RE: Expert Geomorphological Assessment EGA. Sizewell C. Formal request.

Sizewell C—Coastal Considerations and BEEMS TR553 26/4/2022

Ref: Comments on the responses of specified parties the Secretary of State's letters of 18 March 2022 and 31 March 2022. Response to your letter 25 April 2022.

The Sizewell-Dunwich Banks. The purple arrows mark 26700N— to the north of which the crest height of Dunwich bank is lowering. Chart base from BEEMS Technical Report TR500 'Sizewell-Dunwich Bank Morphology and Variability'. Page 14. Markup my addition.

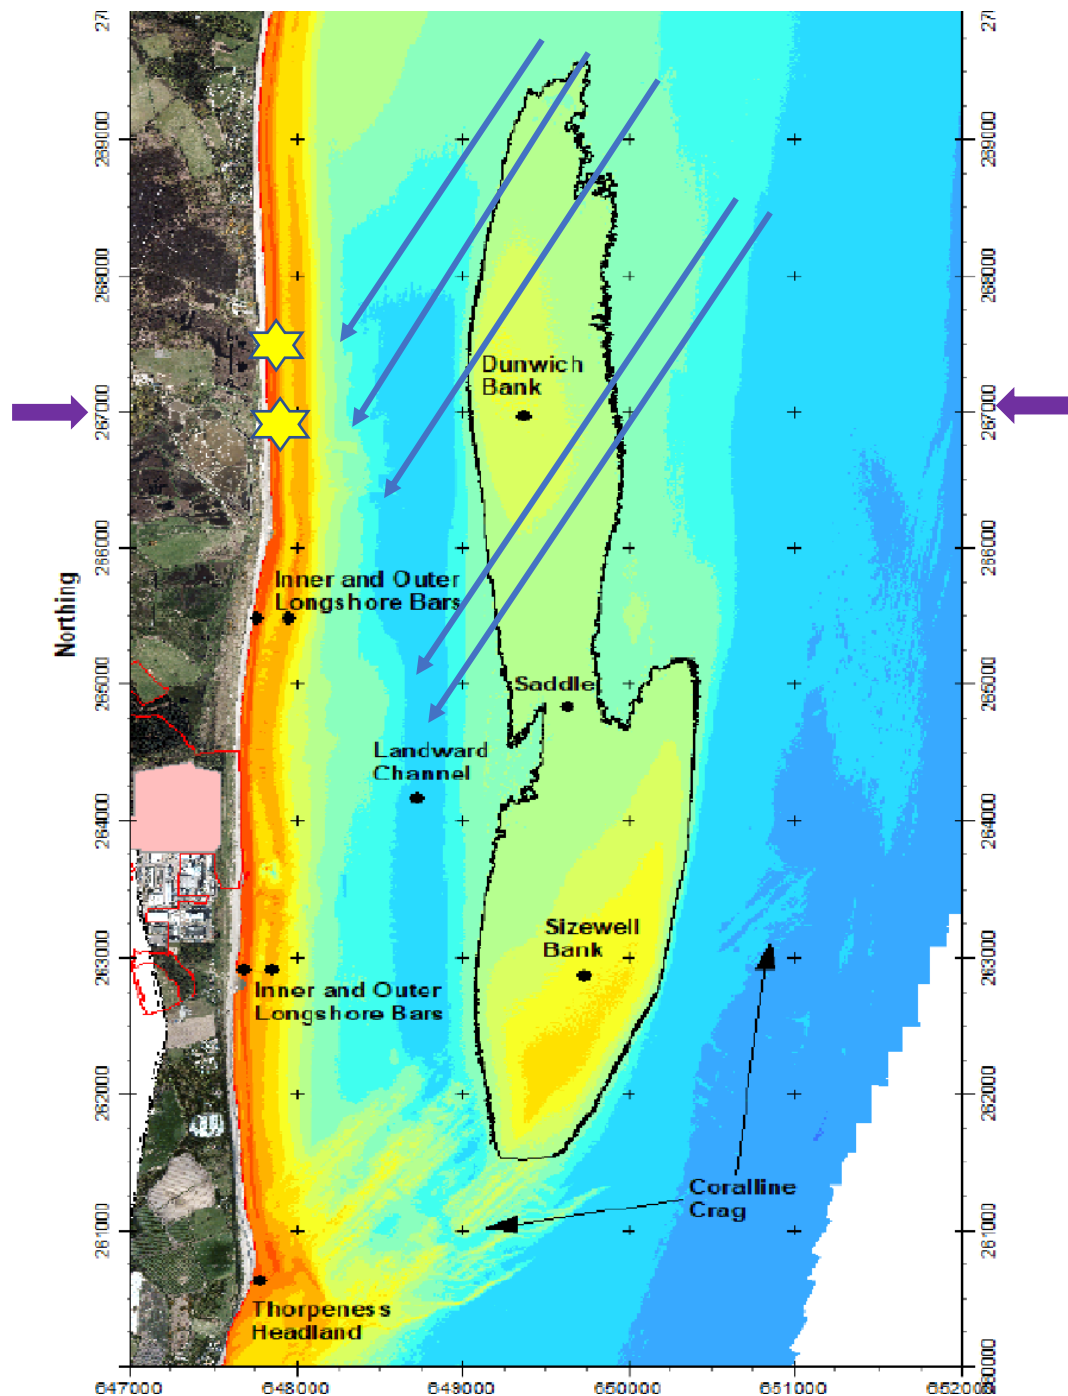
- The orange and red lines show the 'inner and outer' nearshore, longshore bars. The DCO provided detailed bathymetry of the inner and outer Longshore bars and not the Sizewell-Dunwich banks.
- The pink square shows the proposed location of Sizewell C.

- ***“Records over the last decade show...Dunwich Bank exhibited greater variability in both its morphology and position with erosion north of 267000N, [shown by the purple arrows] resulting in bank lowering of -0.5 to -1.5 m”*** DCO: Geomorphology Appendix 20A, op cit., Page 21. BEEMS Technical Report TR500).
- The five blue arrows show the direction of the most significant storm waves from the North/North East— ***the largest and longest waves arrive from the N-NE sector. [1:100 wave heights 7.3m-7.8m]***. The driver of sudden and significant erosion on this stretch of coast is from the NNE NE and Easterly directions. The loss of just the northern section of the bank could allow unbroken storm waves to break on the foreshore and increase water volumes in the South Minsmere levels in flood conditions. See map in section 4.3. DCO: Geomorphology Appendix 20A. op.cit., Paragraph 2.3.2.2.2

Haskoning’s modelling assumes ‘shore-normal’ angles (all waves will strike the shore at 90 degrees). In the complex bathymetry offshore from Sizewell plus significant wave directions stated above do not appear to support this assumption. Shallow nearshore (even before the nearshore bar locations) wave refraction locally will redirect waves and cause them to line up parallel to local bathymetric contours. section 7.

- There has been net erosion of the foreshore in the area of the proposed Sizewell C since 1993 according to BEEMS Table 2. This may be an indication of compromise to the Dunwich bank. See BEEMS TR223 op cit., Page 119 and Table 12 on page 115.
- The two yellow stars show the locations of breaches - 267400 15/12/03 and 14/2/05 and 266900 14/2/05. ***“This 200 m section is the most vulnerable stretch of coastline between Dunwich and Sizewell, and represents the most likely location of a major breach occurring during a future storm surge.”*** Pye and Blott 2005, Coastal evolution RSPB op. cit., page 154 of 160. Page 28/160

1. Orange arrow shows erosion period 1736-1836.
2. Light blue arrow shows accretion period post the development of the Sizewell-Dunwich banks, 1836-1920.
3. Light green double arrow shows the relative stability period 1920- present.

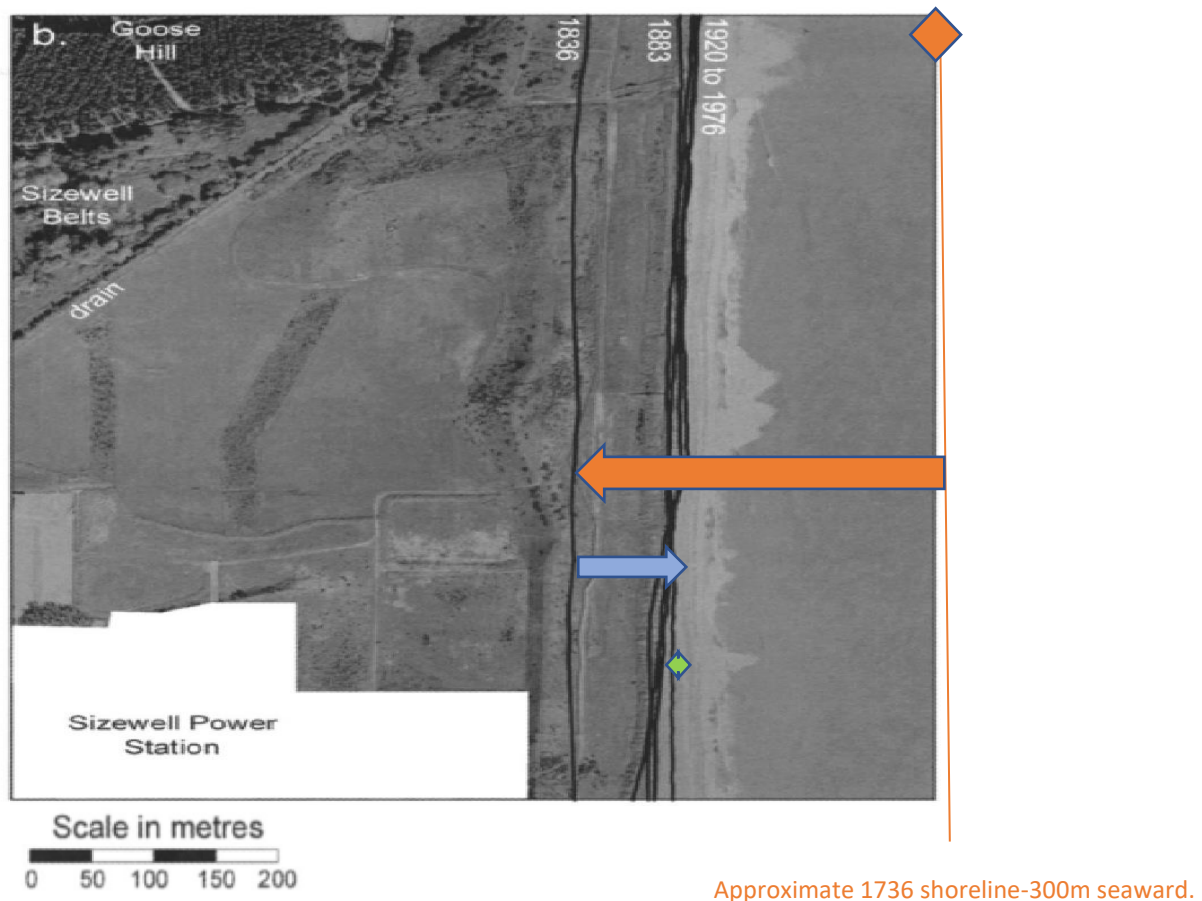
Three 'approximately 100-year' episodes are recorded for Sizewell:

- 1. Erosion:** As stated above, the Sizewell shoreline between 1736 and 1836 is *"the most eroded shoreline in the records"* according to BEEMS TR058 quoting Pye and Blott (2005). It appears that the 1836 shoreline had eroded approximately 300m in one century and was just 20m seaward of the present-day Sizewell B. Orange arrow in the air photo below.
- 2. Accretion: The Sizewell-Dunwich bank grew after 1824 and protected the shoreline;** between 1836 and 1903/1920 the Sizewell shoreline accreted by 83m with sediment from cliffs to the north, particularly Dunwich, to roughly its present location. The present Sizewell shoreline is hence 'soft and erodible'. Blue arrow on the air photo below.
 - BEEMS states, however, *"The last 2 to 3 decades of strong erosion at Dunwich were not, however, matched by ongoing accretion in the south"*. BEEMS TR223 op cit., Page 119, Table 12 on p. 115.

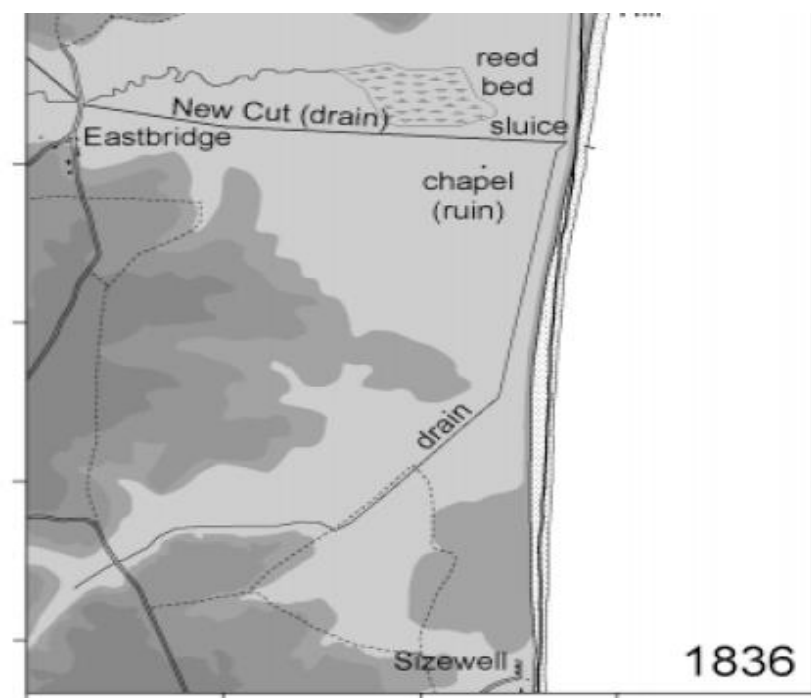
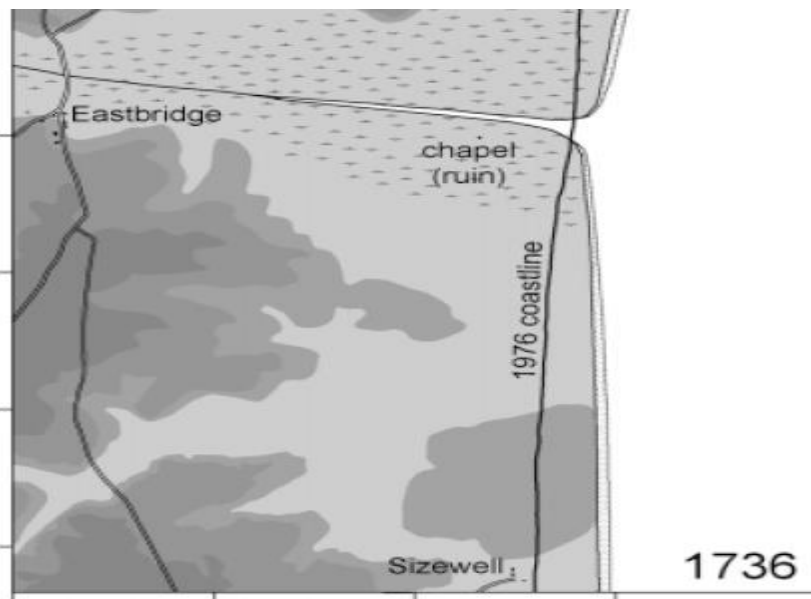
The following two historical maps illustrate the coastline in 1736 and 1836. The 1736 shoreline according to Pye and Blott appears to be approximately 300m-350m to seaward of Sizewell B and as stated earlier is "...the most eroded shoreline in the records assembled by Pye and Blott (2005)".
